SERVICE BULLETIN

Specification/change of engine configuration and/or type plate for ROTAX® Engine Type 912 and 914 (Series)

MANDATORY

Fig. 1

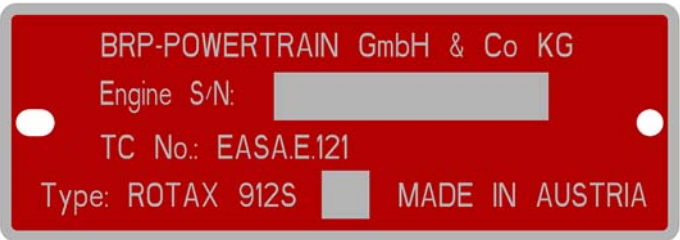
Suffix	Description	Note
-01	<p>New cylinder heads have been introduced for the ROTAX 912/914 engine Series in order to standardize the cylinder head raw part with the ROTAX 912 iS Sport engine series. As a result the measurement position of the temperature sensor on the cylinder head has changed as well as the measurement medium (former aluminium, now coolant).</p> <p>As a consequence for all ROTAX 912/914 engines which type designations are extended with suffix “-01” the engine temperature measurement methods have been amended from CHT (cylinder head temperature) and CT (coolant temperature) to only CT (coolant temperature). Therefore only the coolant temperature limit applies.</p> <p>Example for identification: “ROTAX 912 ULS3 -01”</p>	<p>Engines from serial number 912 A: 4 411 087 912 F: 4 413 045 912 S: 4.924 911 914 F: 4 421 445 are already equipped with a new type plate with suffix, which has been extended to some more information (see Fig. 1).</p>

Step	Procedure
1	Apply suffix - 01 permanently (e.g. engraved, stamped or similar) to the type plate. NOTE: Any changes regarding to this Service Bulletin must be confirmed in the engine logbook.

OLD

**OLD
CHANGED**

NEW
